C O N V A I R

COMMERCIAL CHANGE PROPOSAL

SPEC NO.: ZD- 22-002

CUSTOMER: Hughes Tool Company

FIGURE 3.19-9

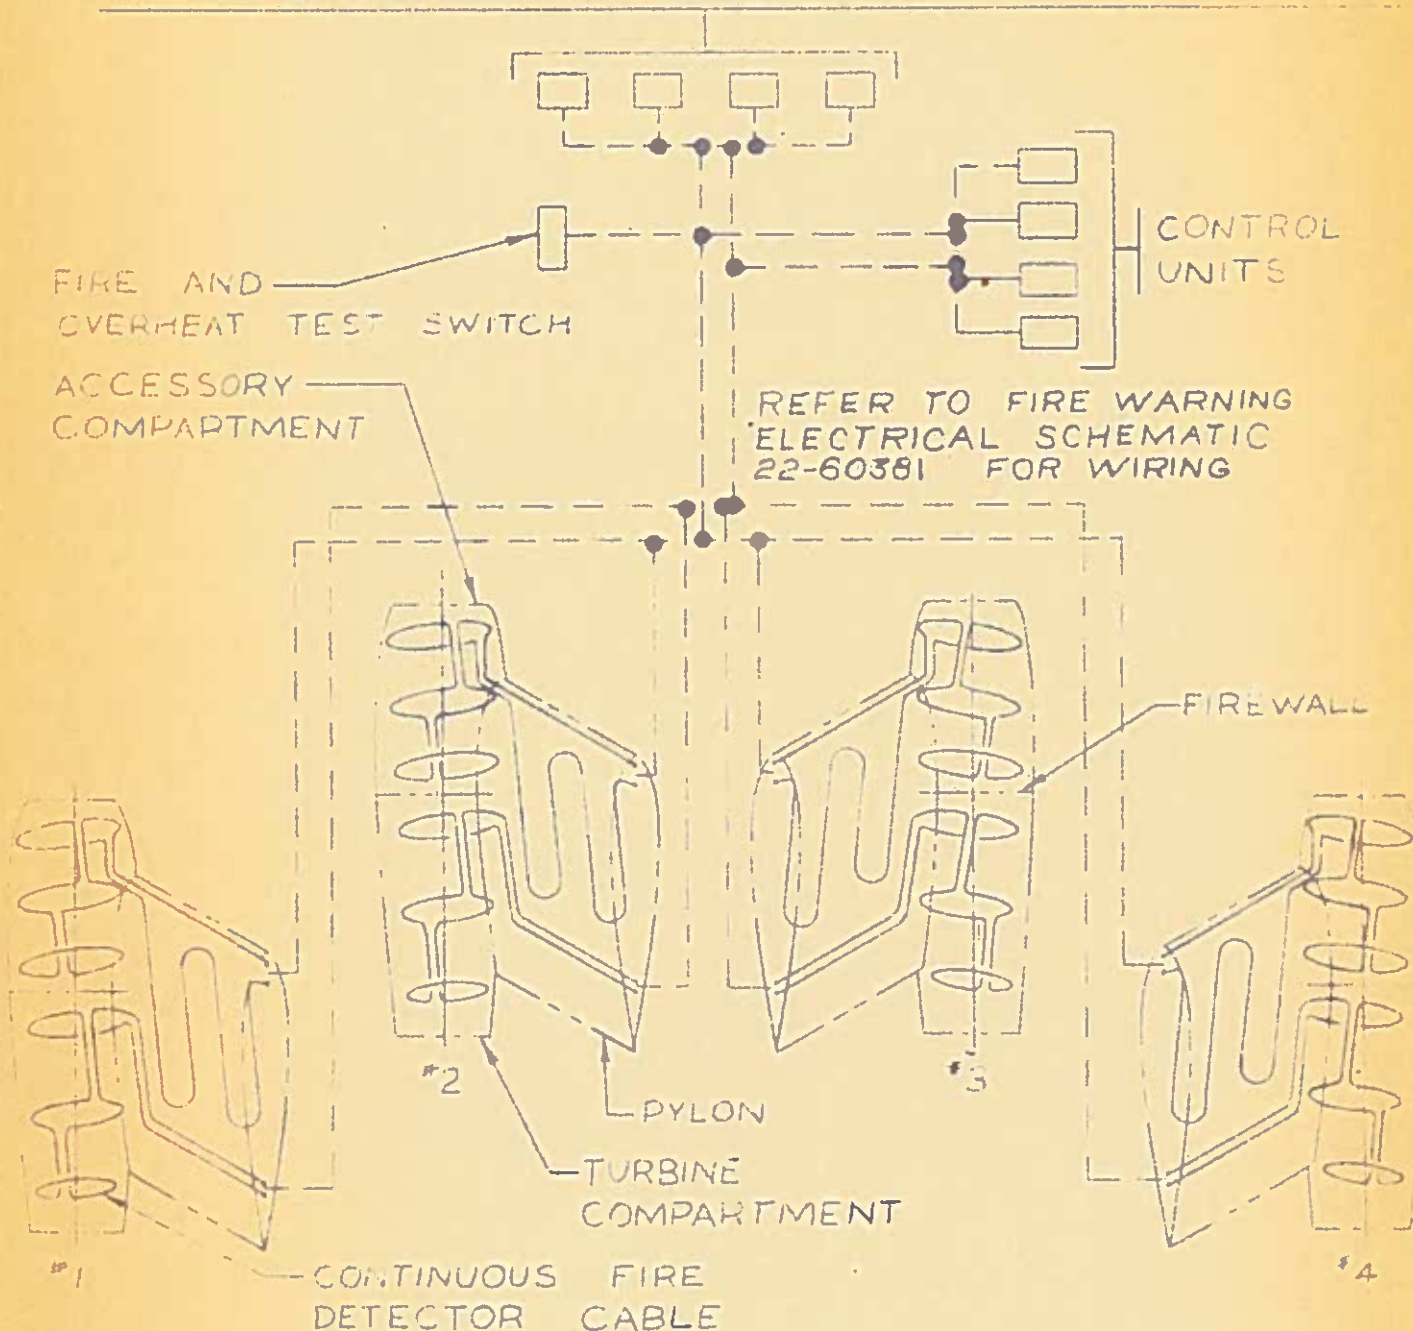
Enclosure (A): One (1) copy of Figure 3.19-9 FIRE DETECTOR SYSTEM,
ENGINE NACELLES AND PYLONS (Revised 1-23-58)

FIGURE 3.20-1

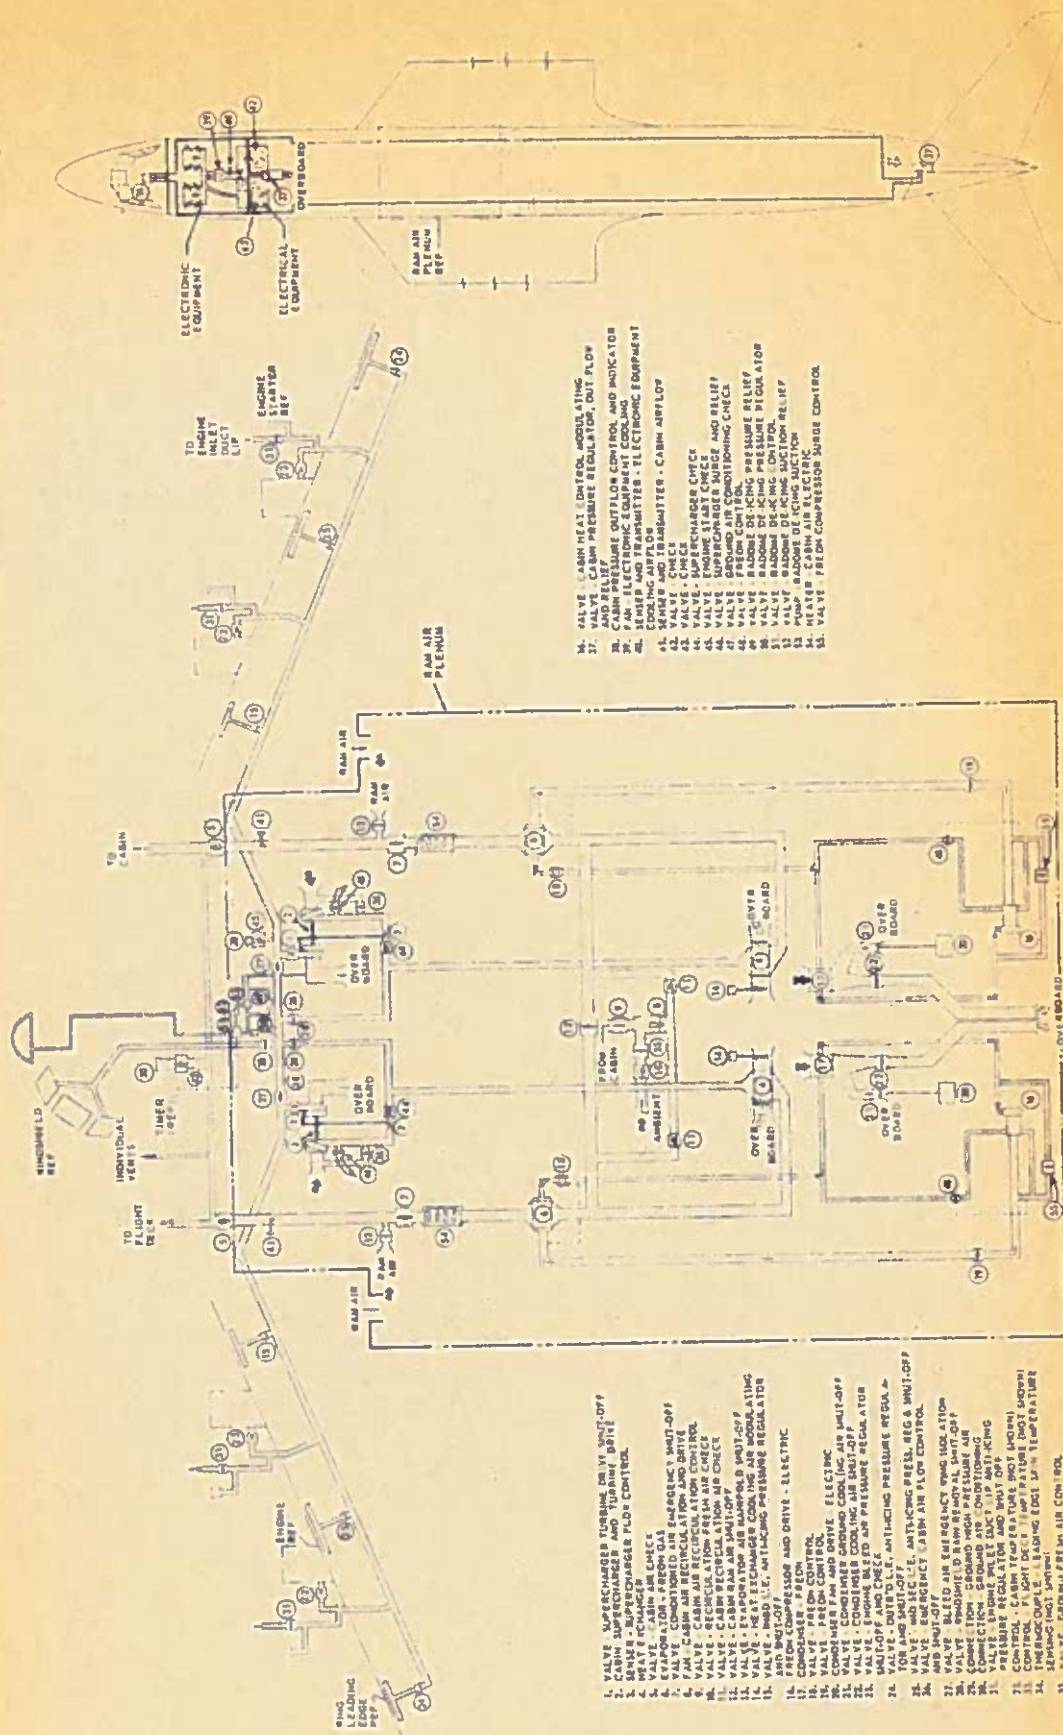
Enclosure: (A) One (1) copy of Figure 3.20-1 AIR CONDITIONING PRES-SURIZATION SYSTEM

"Antenna Arrangement"

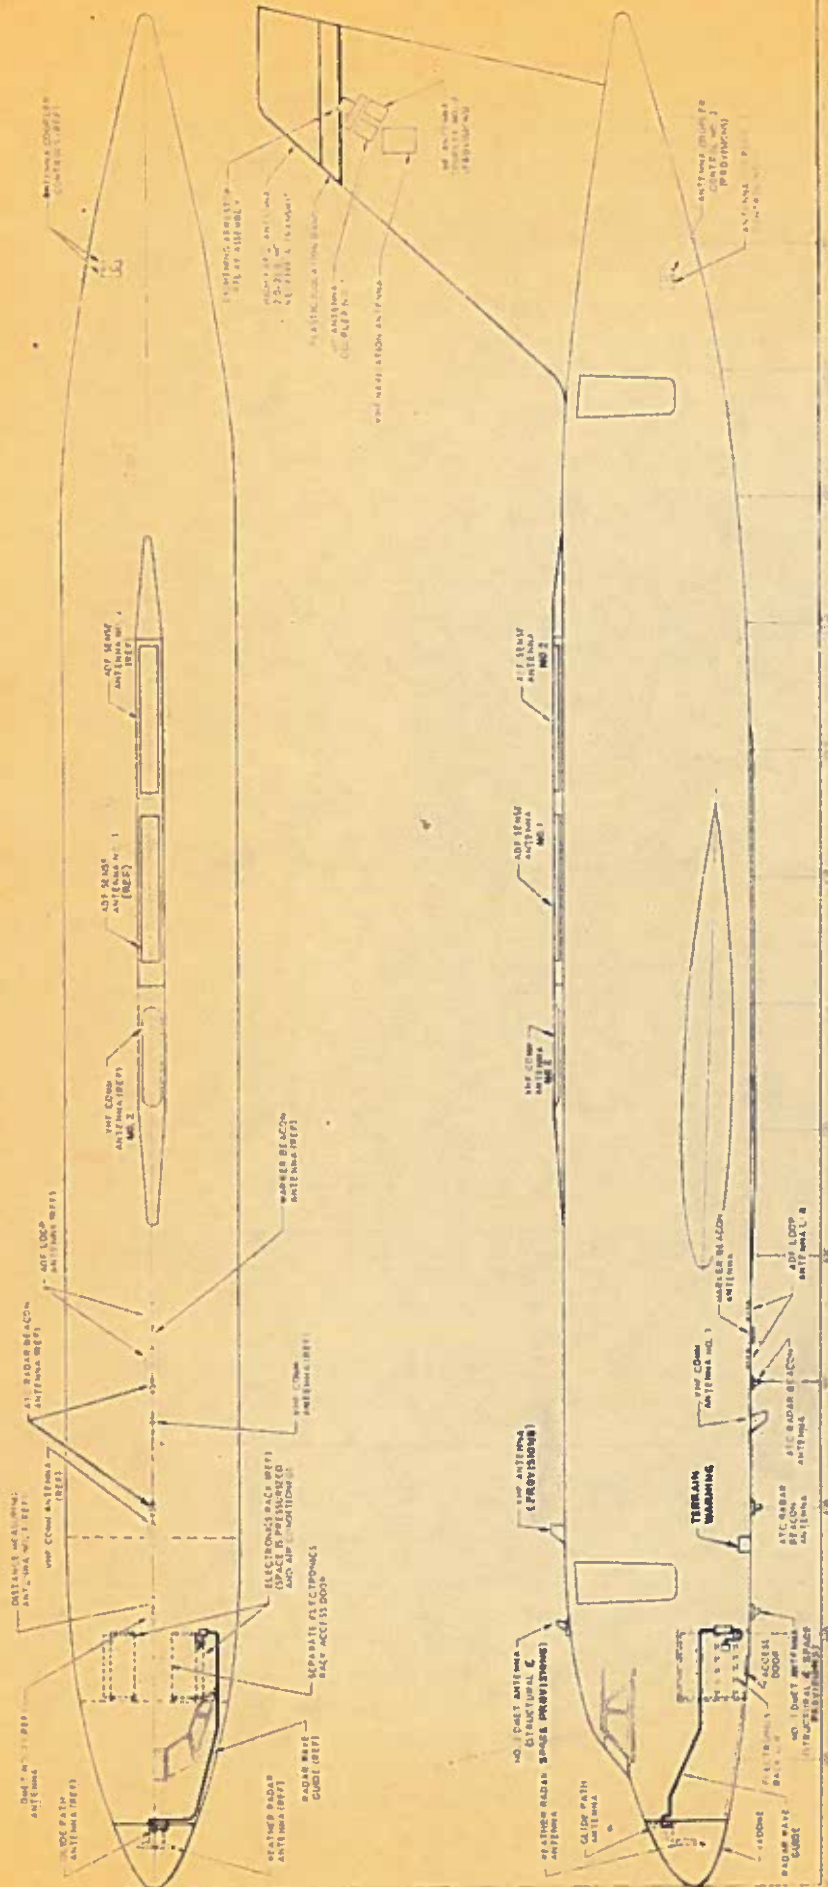
Page 104C, add the following illustration:
